Company	Trenz Electronic GmbH
PCN Number	PCN-20250401
Title	TE0835-02 to TE0835-03 Hardware Revision Change
Subject	Hardware Revision Change
Issue Date	2025-05-26

This change affects all Trenz Electronic TE0835 SoMs of revision 02: TE0835-02*.

#32 Updated layerstack.

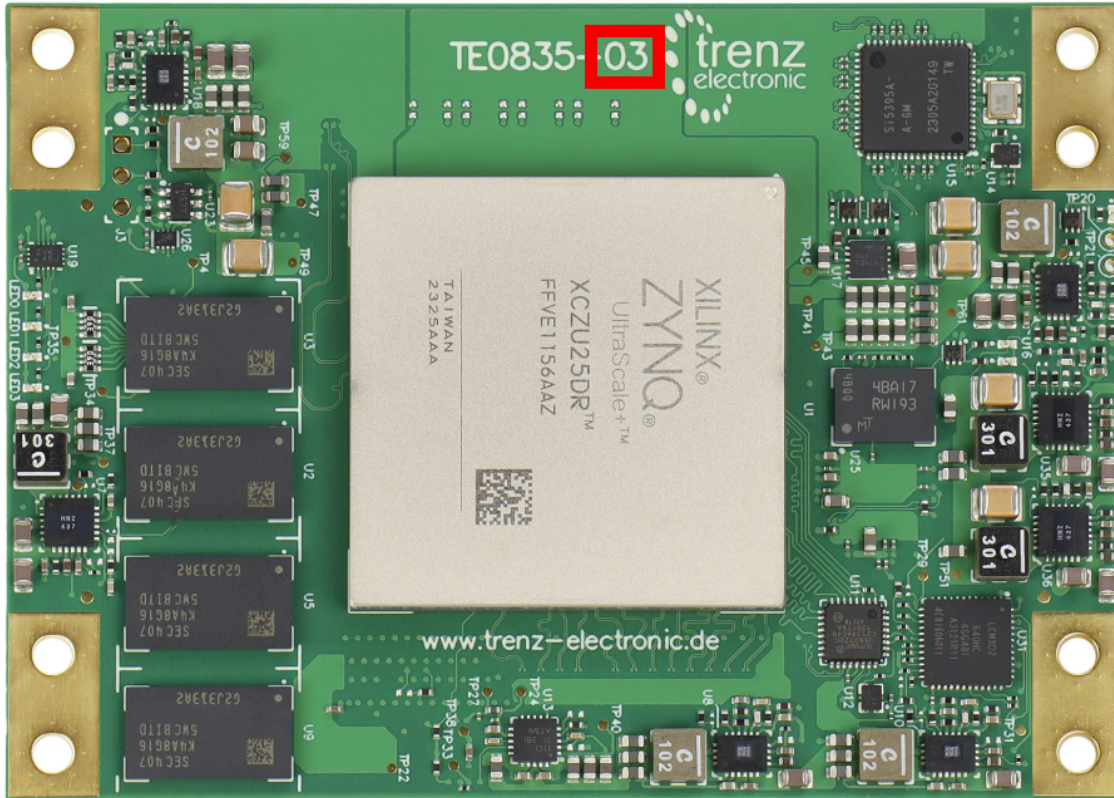
Reason: Improve power supply circuits and trace impedances.

Impact: Improved power supply and trace impedance behaviour.
